# Cleveland Road North & South Planning Proposal

**Traffic Impact Assessment**

Newquest Property Pty Ltd

## RESPONSE SCHEDULE

Figure 4.1: Proposed Development Roads in the Contributions Plan 2020

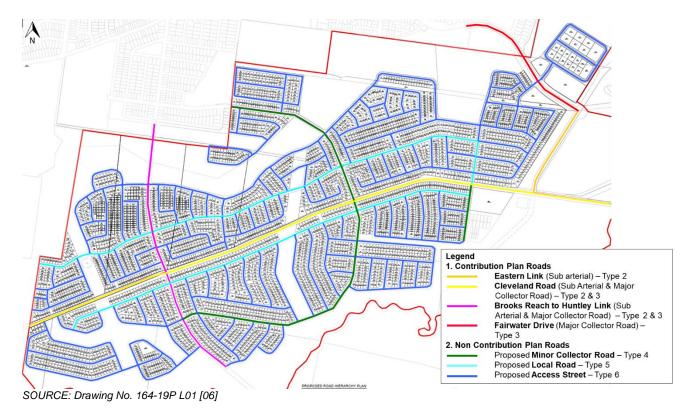
The proposed road hierarchy must be shown on the plans.

The proposed road hierarchy should be shown on the plans.

Response: Please refer to Section 4.1

Response: Please refer to Section 4.1

Figure 5.1: Proposed Pathways

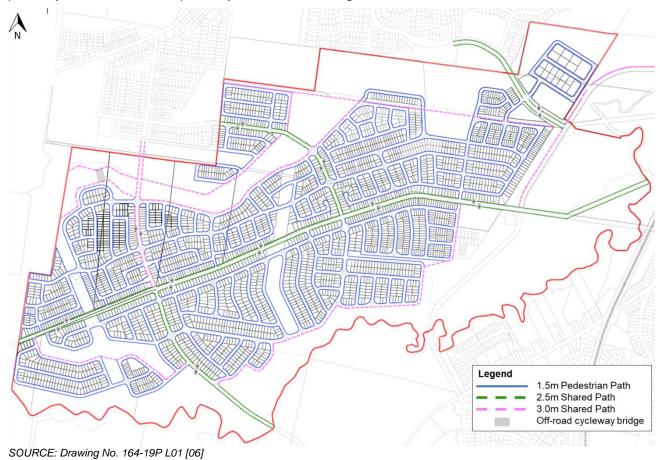
The Rezoning Plan and Neighbourhood Plan must show riparian cycleway routes as per the layouts in the S7.11 plan

The transmission easements could be used for convenient pedestrian/ cycle connections to/ from riparian cycleway links.

The Rezoning Plan and Neighbourhood Plan must show riparian cycleway routes as per the layouts in the s94 plan

The transmission easements could be used for convenient pedestrian/cycle connections to/from riparian cycleway links.

Response: Please refer to Section 5

Response: Please refer to Section 5

Response: Please refer to Section 5

Response: Please refer to Section 5

Figure 6.1: Proposed Development Public Transport

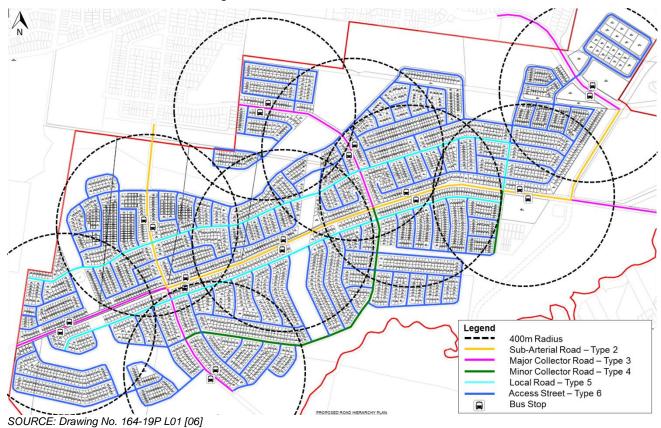
Indicative bus stop locations need to be shown on the plans in accordance with NSW bus operator guidelines for bus stop spacing, showing development accessibility to the stops (ie within 400m of a bus stop)

Indicative bus stop locations need to be shown on the plans in accordance with NSW bus operator guidelines for bus stop spacing, showing development accessibility to the stops (ie within 400m of a bus stop)

Response: Please refer to Section 6

Response: Please refer to Section 6

Indicative bus stop locations shown in Figure 6.1 are in accordance with NSW bus operator guidelines for bus stop spacing, showing development accessibility to the stops (i.e. within 400m of a bus stop).
